UNITED STATES PATENT AND TRADEMARK OFFICE

APPLICATION NO.	FILING DATE	FIRST NAMED INVENTOR	ATTORNEY DOCKET NO.	CONFIRMATION NO.
09/808,818	03/15/2001	Ryuichi Murai	NAK1-BO22	5636

Office Action Summary

DETAILED ACTION

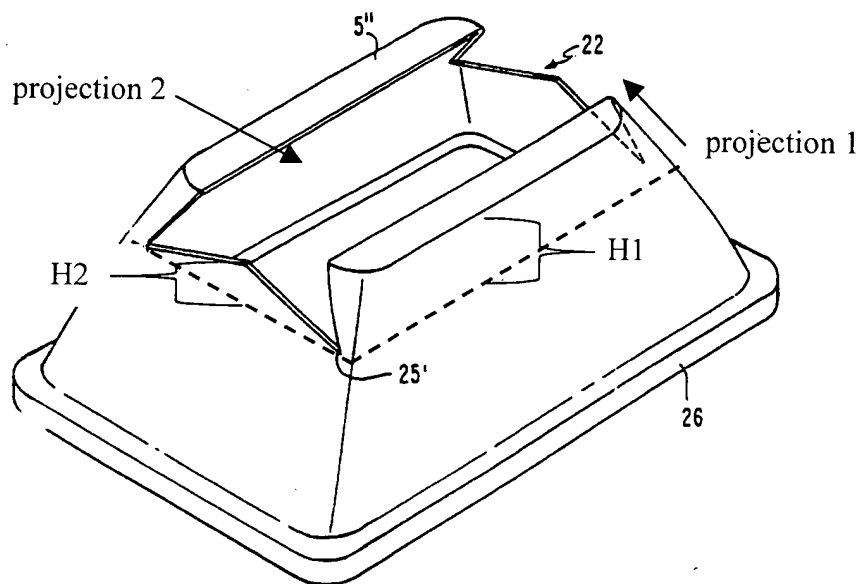
19. Claims 1-7, and 10 are rejected under 35 U.S.C. 103(a) as being unpatentable over Van Mensvoort (USPN 5,363,010).
20. In regards to claims 1-7, Van Mensvoort discloses in figure 8, a CRT comprising a beam trajectory deflection means (5) which deflects an electron beam in a direction opposite to an electron beam deviation, and further that an equivalent height H1 is greater than an equivalent height H2 (see below).

21. Van Mensvoort is silent to the exact properties of the magnetic shield particular regards to a magnetic flux's propagation in the CRT, the relationship of magnetic flux density, and the curvature of the magnetic flux.

22. However, one of ordinary skill in the art can see that Van Mensvoort's shield comprises a magnetic flux which proceeds in a general direction of a tube axis, and further, that the shield has $R1 > R2$, $B1 > \phi 2$, $R1 > R2$, and $R1_{center} > R2_{edge}$, and these properties are inherent to the shape and structure of the shield.
